Plan Holders of: **11th Street East Tracy Overhead Bridge Replacement Project**
CIP 73063

Subject: Addendum No. 1

ADDENDUM NO. 1

Plan Holders of: **11th Street East Tracy Overhead Bridge Replacement Project**
CIP 73063

SHEET 2
OF 260 SHEETS

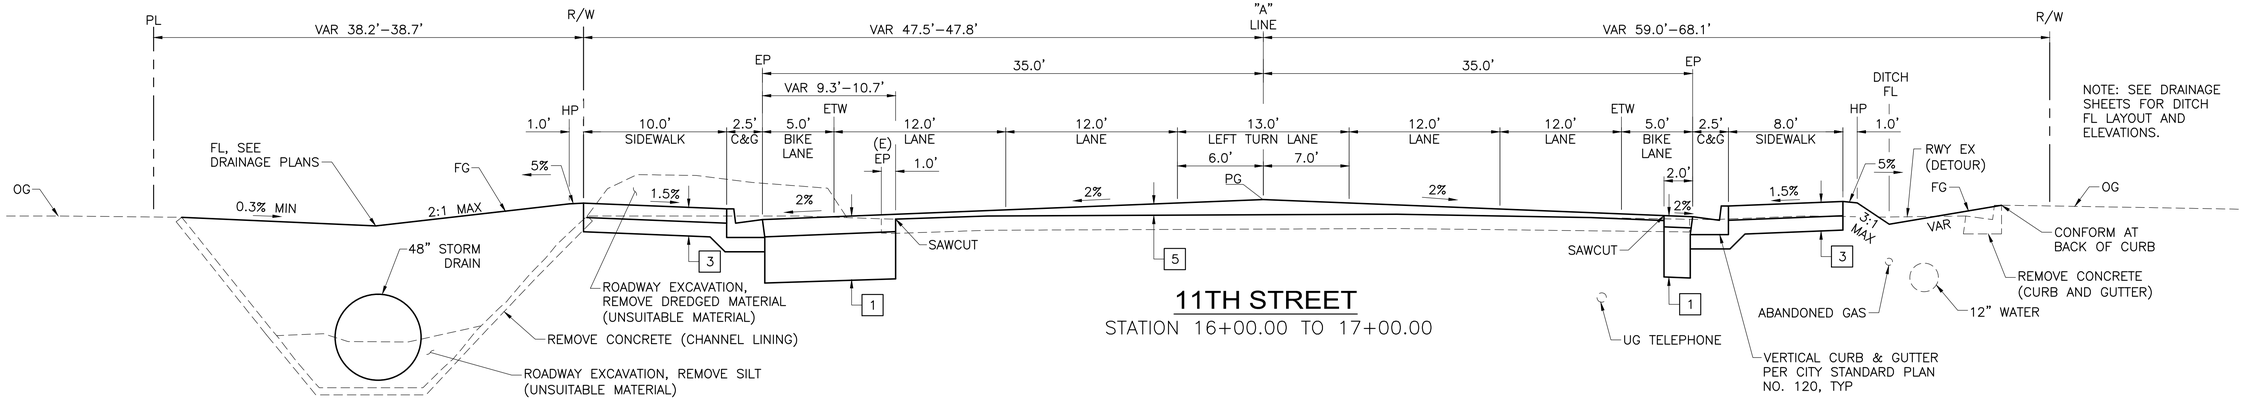
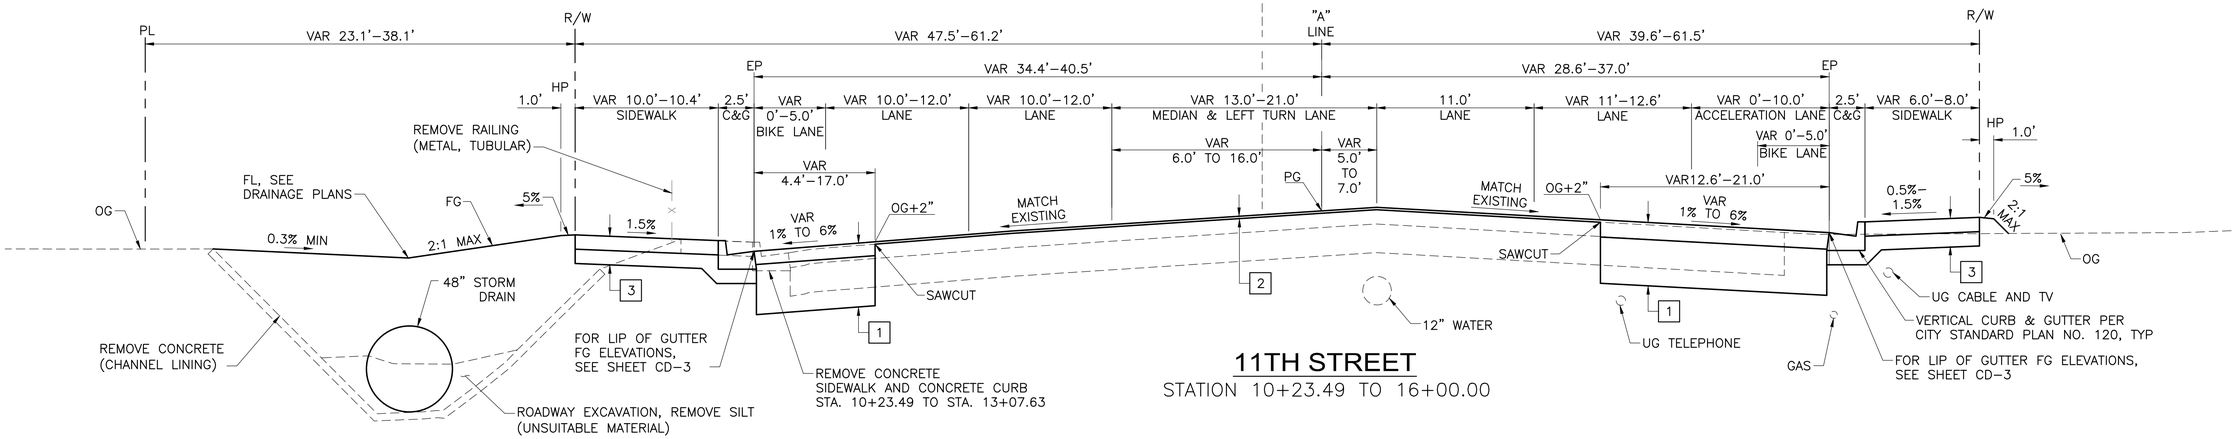
Item No. 1: PROJECT PLANS - Sheet 2 of 260, TYPICAL SECTIONS (Drawing X-1):

- Under Typical Structural Section #5, "GRIND" has been replaced with "COLD PLANE".

SHEET 19
OF 260 SHEETS

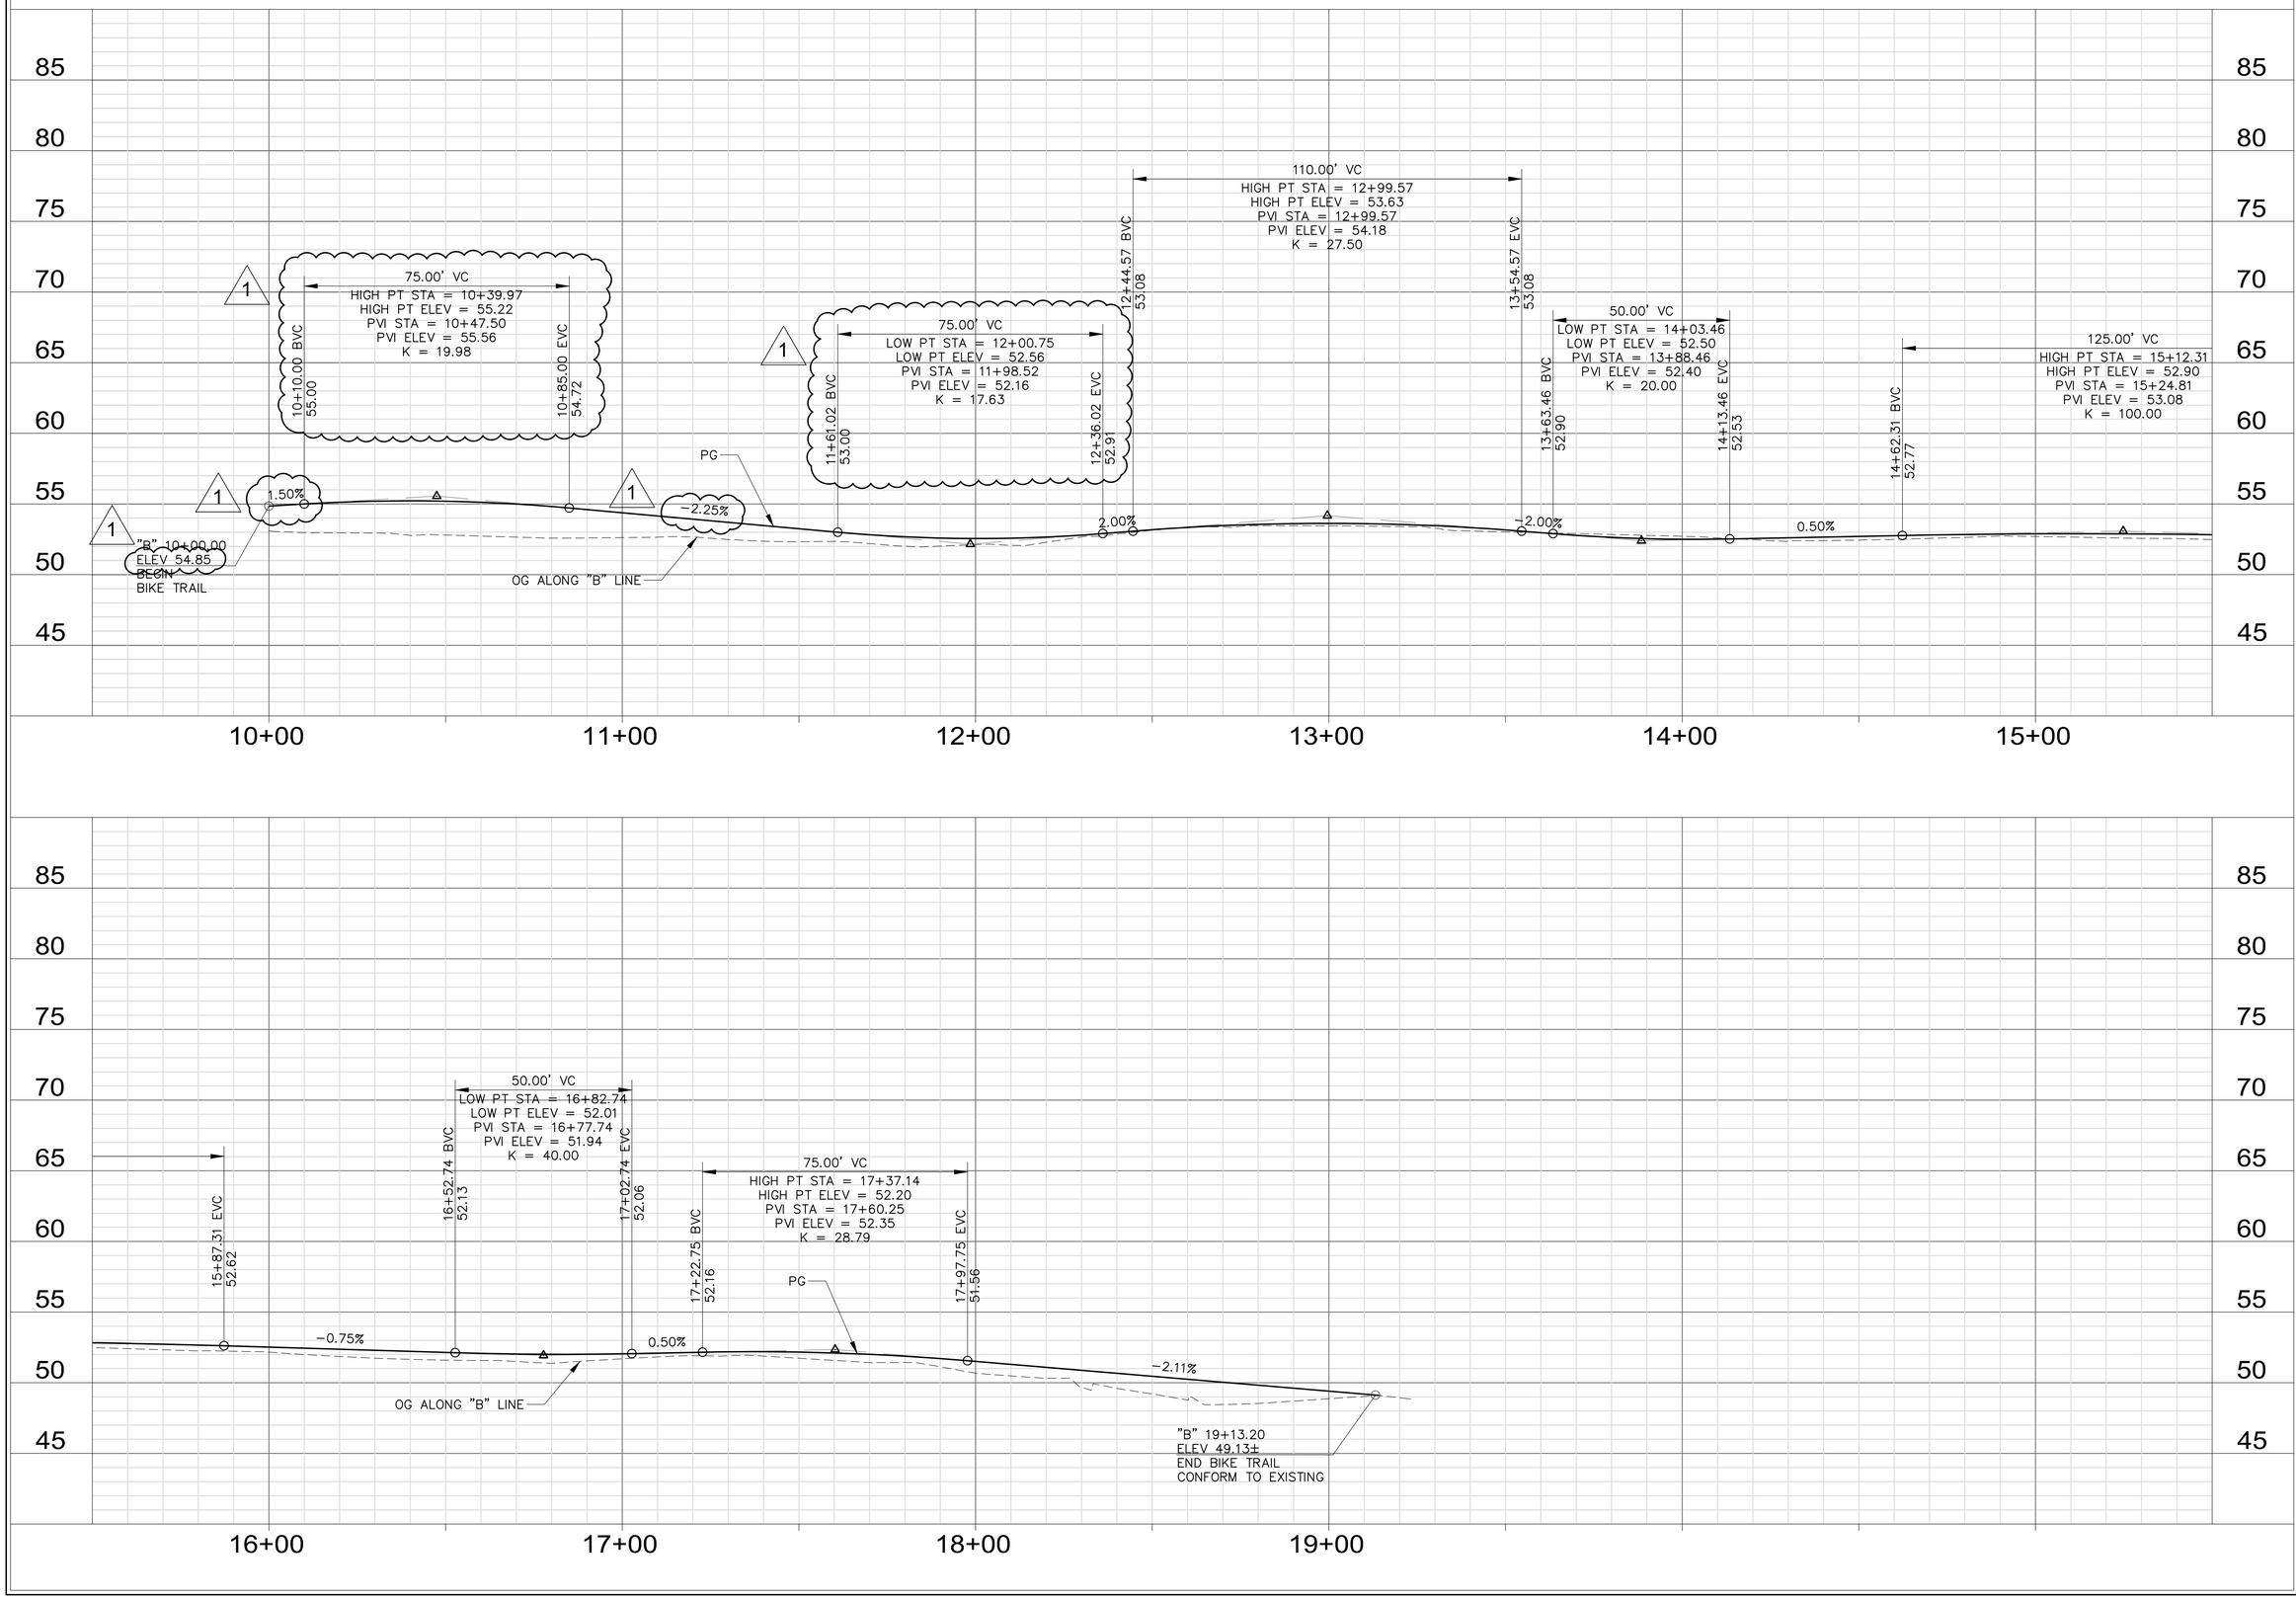
Item No. 3: **PROJECT PLANS –** Sheet 13 of 260, REMOVALS PLAN (Drawing RE-5); Sheet 19 of 260, LAYOUT (Drawing L-5); Sheet 47 of 260, DRAINAGE PLAN (Drawing D-5); Sheet 71 of 260, UTILITY RELOCATION STAGING PLAN (Drawing U-5); Sheet 79 of 260, STAGE 1 CONSTRUCTION-TRAFFIC HANDLING (Drawing SC-5); Sheet 85 of 260, STAGE 2 CONSTRUCTION-TRAFFIC HANDLING (Drawing SC-11); Sheet 91 of 260, STAGE 3 CONSTRUCTION-TRAFFIC HANDLING (Drawing SC-17); Sheet 98 of 260, STAGE 4 CONSTRUCTION-TRAFFIC HANDLING (Drawing SC-24); Sheet 105 of 260, STAGE 5 CONSTRUCTION-TRAFFIC HANDLING (Drawing SC-31); Sheet 112 of 260 STAGE 6 CONSTRUCTION-TRAFFIC HANDLING (Drawing SC-38); Sheet 124 of 260, DETOUR LAYOUT (Drawing DE-5); and Sheet 168 of 260, RETAINING WALLS NO.4, NO.5, & NO.6 FOUNDATION PLAN (Drawing R-12):

- Recently placed irrigation pipe and standpipe added
- Added irrigation ditch by others and added callouts regarding existing irrigation standpipes capped below grade and protecting existing irrigation facilities in place to Drawing U-5

WEDGE GRIND

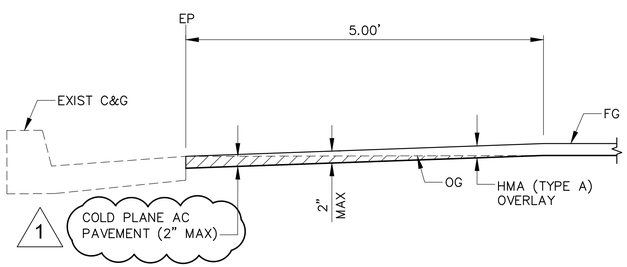
Item No. 5: **PROJECT PLANS -** Sheet 35 of 260, CONSTRUCTION DETAILS (Drawing CD-7):

- "COLD PLANE AC PAVEMENT (2" MAX)" added to Wedge Grind Detail

WICK DRAIN LAYOUT

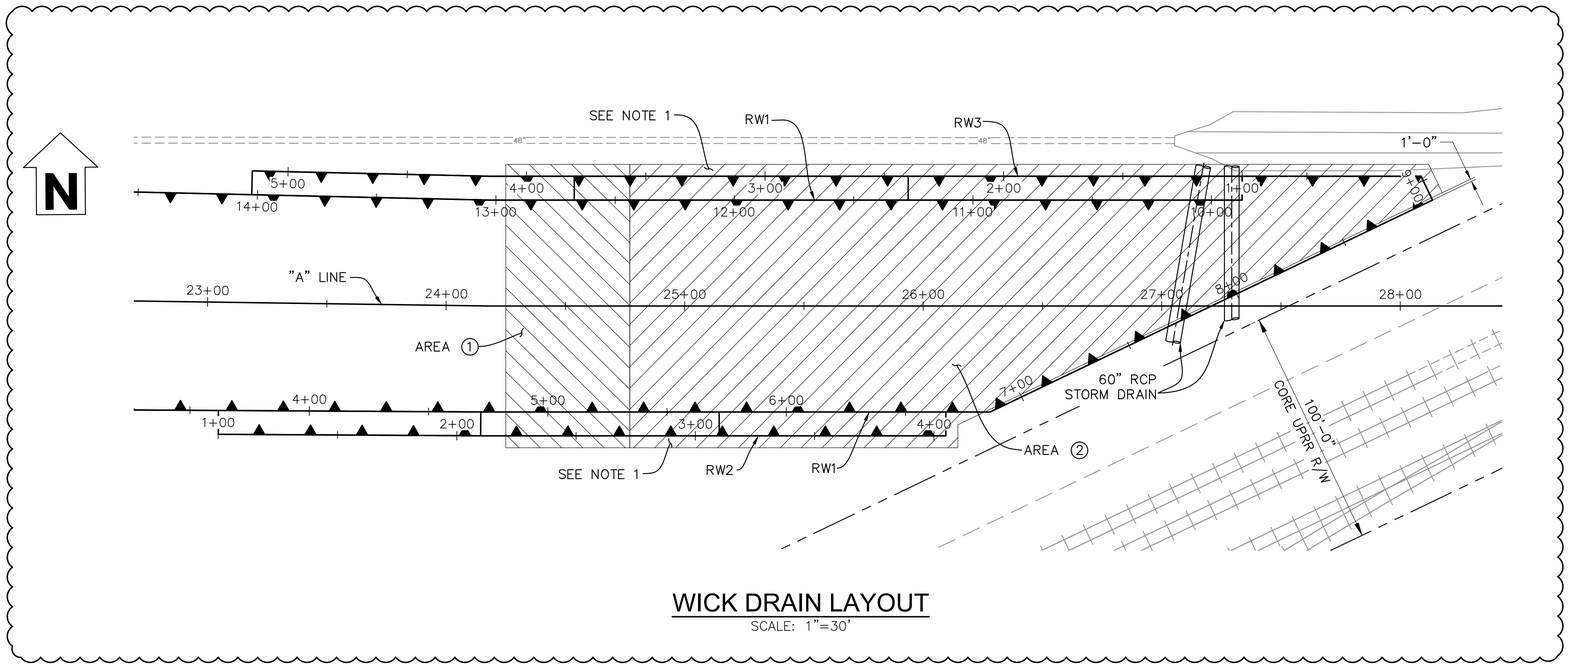
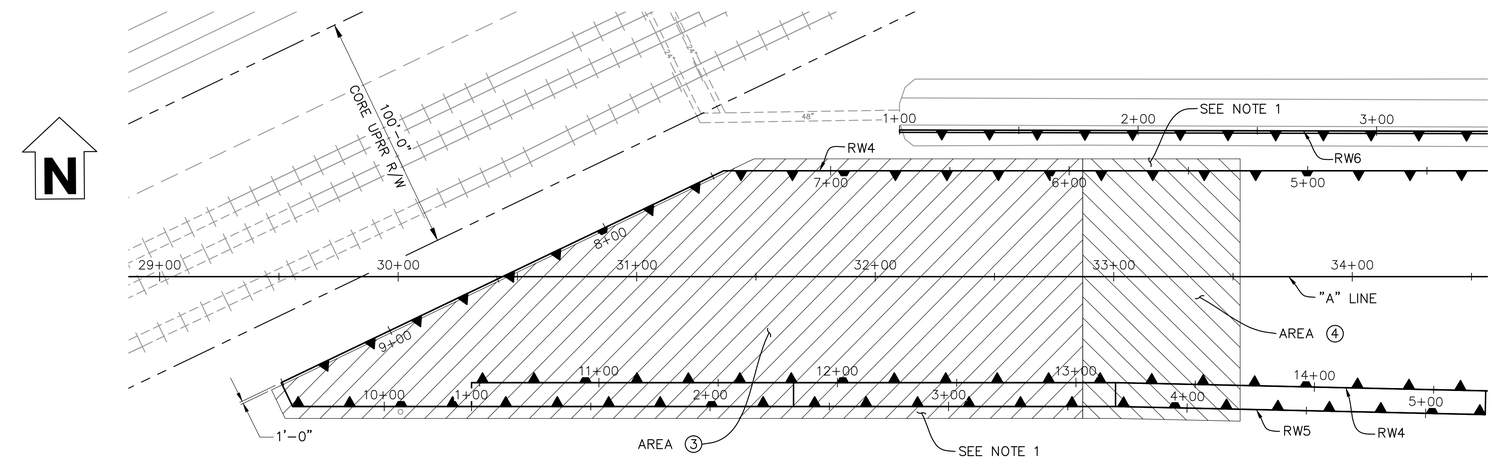
Item No. 6: **PROJECT PLANS –** Sheet 39 of 260, CONSTRUCTION DETAILS (Drawing CD-11), and Sheet 41 of 260, CONSTRUCTION DETAILS (Drawing CD-13):

- Added 60" RCP Storm Drain Pipes to the "Wick Drain Layout" near Abutment 1 on Drawing CD-11
- Added 60" RCP Storm Drain Pipes to the "Wick Drain Layout Detail" and added wick omission/relocation notes for wicks in conflict with 60" RCP Storm Drain Pipes to Drawing CD-13

11th ST EAST TRACY OVERHEAD
DRAINAGE PLAN

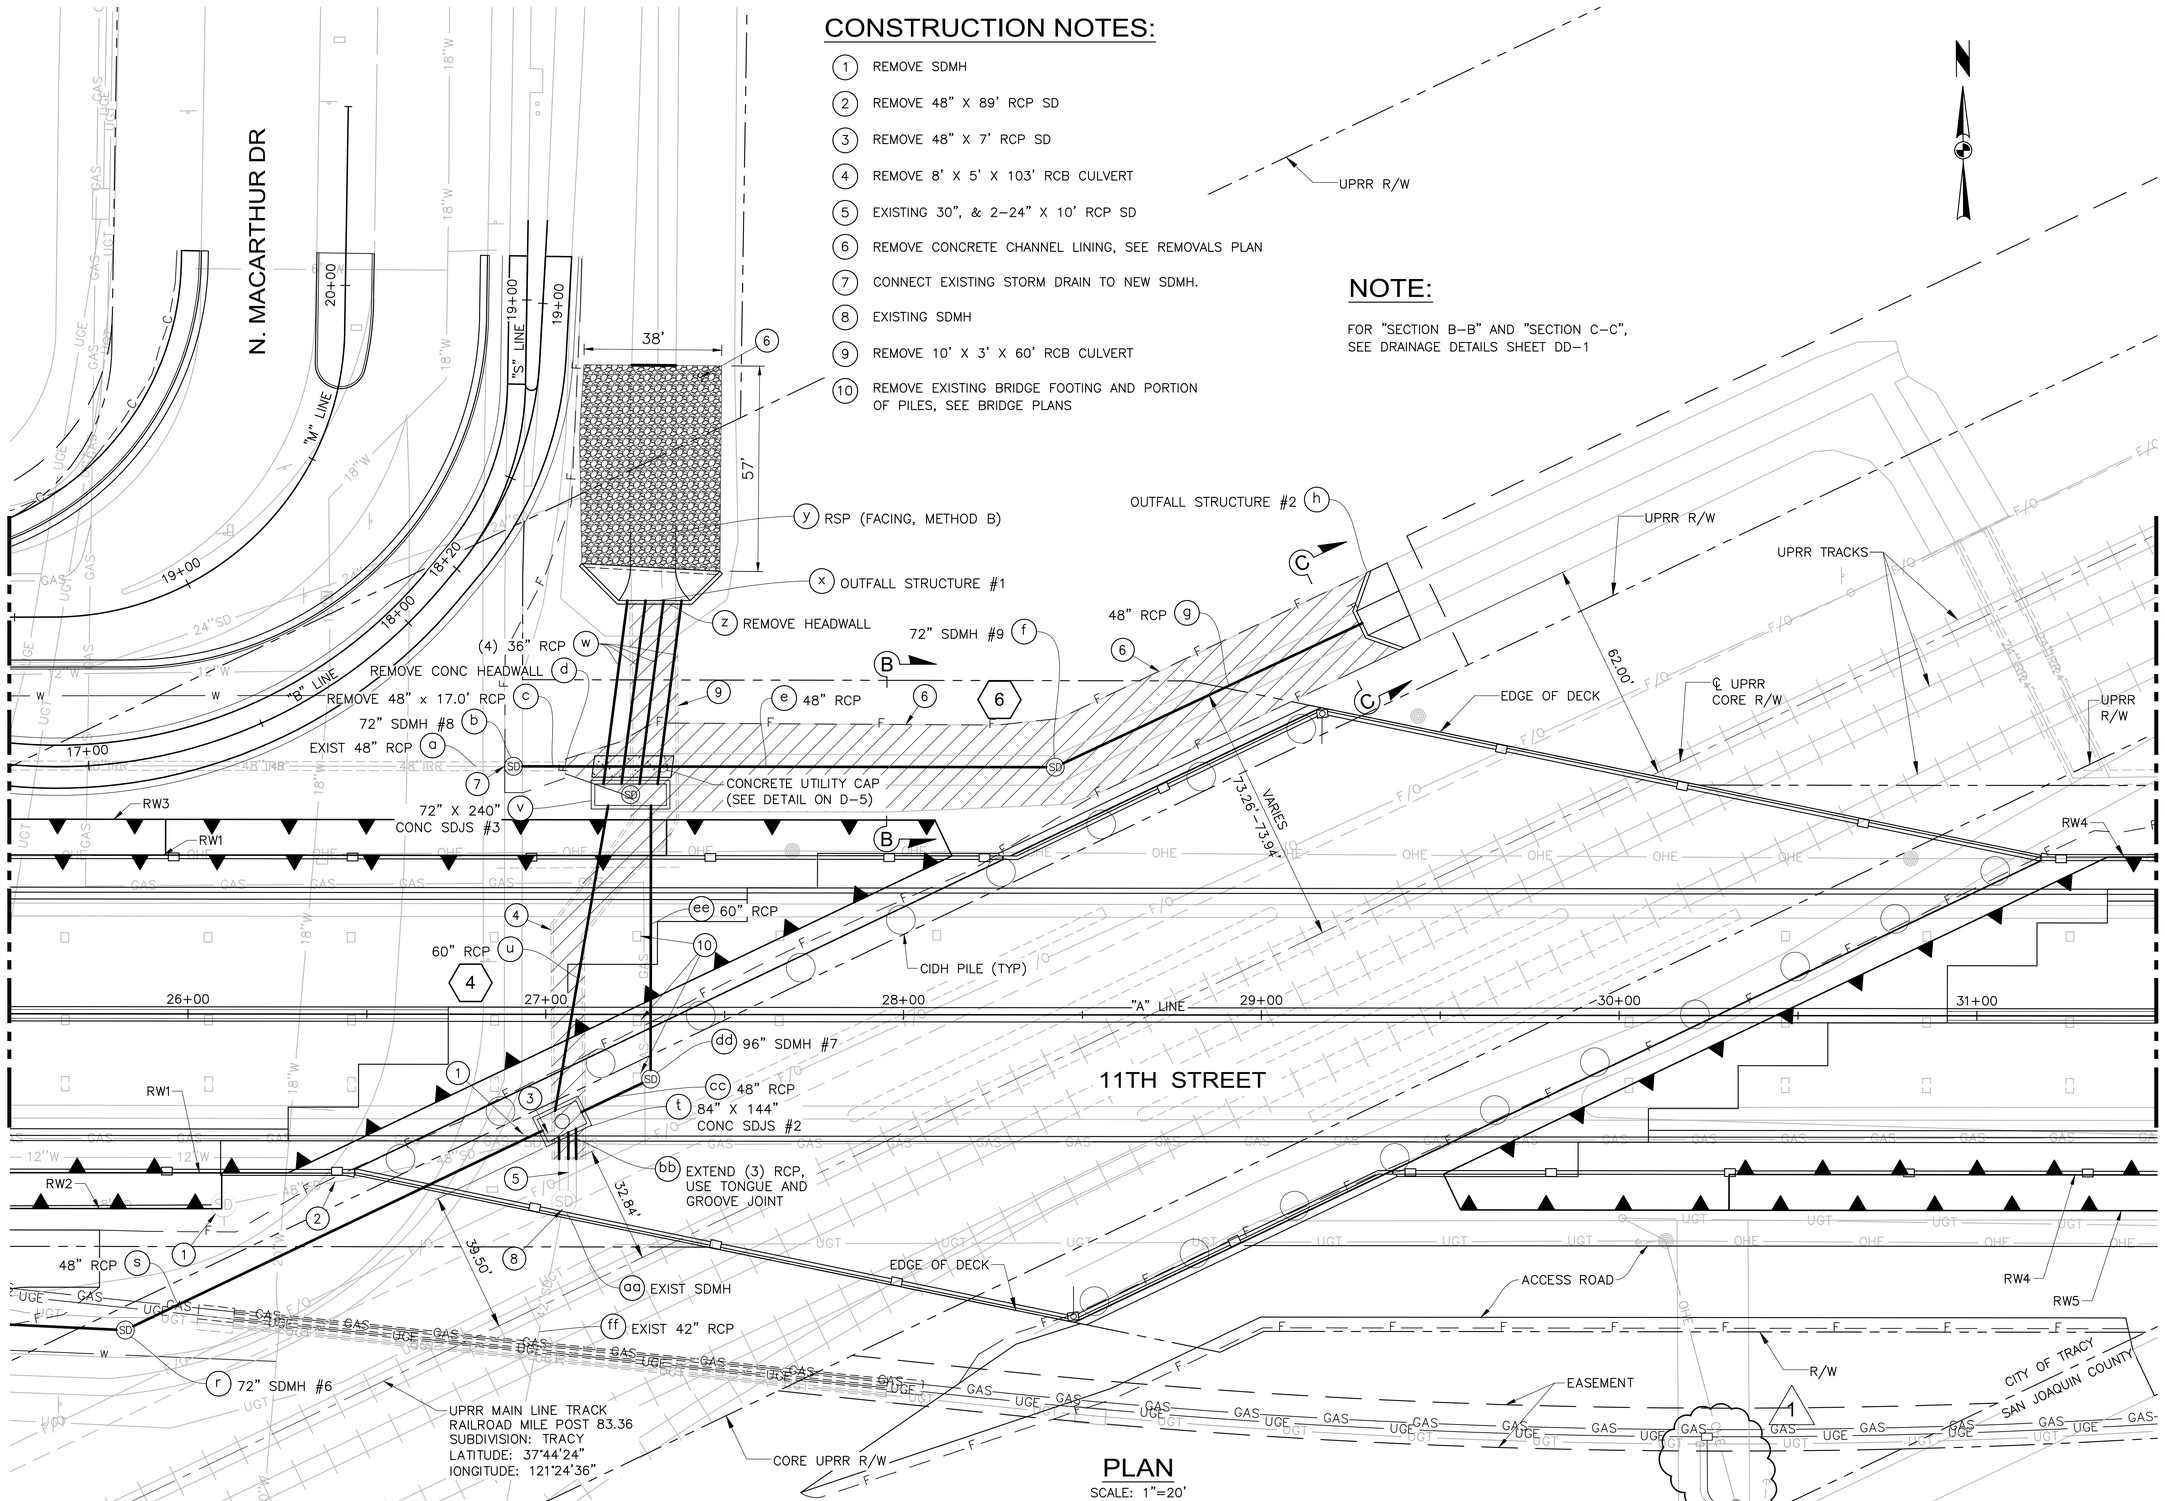
Item No. 2: **PROJECT PLANS –** Sheet 12 of 260, REMOVALS PLAN (Drawing RE-4); Sheet 46 of 260, DRAINAGE PLAN (Drawing D-4); Sheet 70 of 260, UTILITY RELOCATION STAGING PLAN (Drawing U-4); and Sheet 167 of 260, "RETAINING WALLS NO. 4, NO. 5, & NO. 6 FOUNDATION PLAN" (Drawing R-11):

- Underground telephone line modified on Drawings RE-4, D-4, U-4 and R-11
- Overhead utility line has been revised from "OHE" to "OHE&T" on Drawing U-4
